WEST VIRGINIA DEPARTMENT OF ENVIRONMENTAL PROTECTION WV/NPDES CONSTRUCTION STORMWATER PERMIT

FACILITY NAME:	Northport Avenue Extenison					REG.	#	EXPIRE DATE:
PERMITTEE	RANSON, CITY OF				WVR1	10191	9/11/2020	
ADDRESS/PHONE:	Attn: ANDREW P	. BLAK	E, CITY MGR					
	312 SO MILDREI	ST C						
	RANSON, WV 25438							
	3047251010							
LOCATION:	39 22 12.95 N77 52 32.83 W					Entry	Date/Time:	5/14/2020 @ 1100
COUNTY:	Jefferson			Exit D	ate/Time:	5/14/2020 @ 1130		
Site Representative				PHOT	os 🛛			
/Phone								
CO-PERMITTEE:					ADDRESS:			
SITE OPERATOR:					ADDRESS:			
PERMITTED	24.4		WEATHER:	Citi	nny	LAST		3/11/2020
ACREAGE			WEATHER.	Sui	iiiy	INSPE	CTION:	3/11/2020
RECEIVING STREAM	M(S) Rocky Marsh	l						NOV:
								W20-19-037-TDH
Regular Mail □ Certified Mail □ Tracking # 70200090000175443202								
OVERALL FACILITY RATING: Unsatisfactory COMPLIANCE OUTCOME Not Immediately Corrected

NOTICE OF VIOLATION

Violation No W20-19-037-TDH

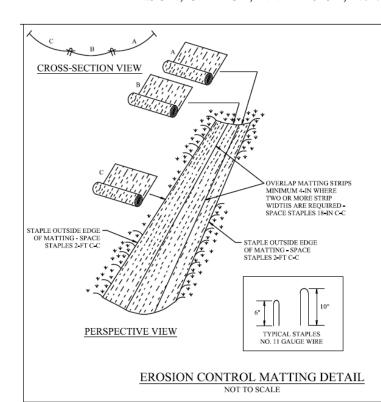
- 1. Section II.F. RANSON, CITY OF has failed to properly implement controls in accordance with standard procedures and as described in the approved SWPPP. Erosion control matting (ECM) is not pinned in with accordance to plan details or manufactures recommendations.
- 2. Section III.A.3.- RANSON, CITY OF failed to provide interim stabilization on areas where the seed has failed to germinate adequately (uniform perennial vegetative cover with density of 70%) within 30 days after seeding and mulching must be reseeded immediately, or as soon as weather conditions allow.
- 3. <u>Appendix A.15-RANSON, CITY OF has failed to post an outlet marker at all permitted outlets from the construction site.</u> Outlet marker was not posted on outlet of basin.

Take measures to correct the aforementioned violations.
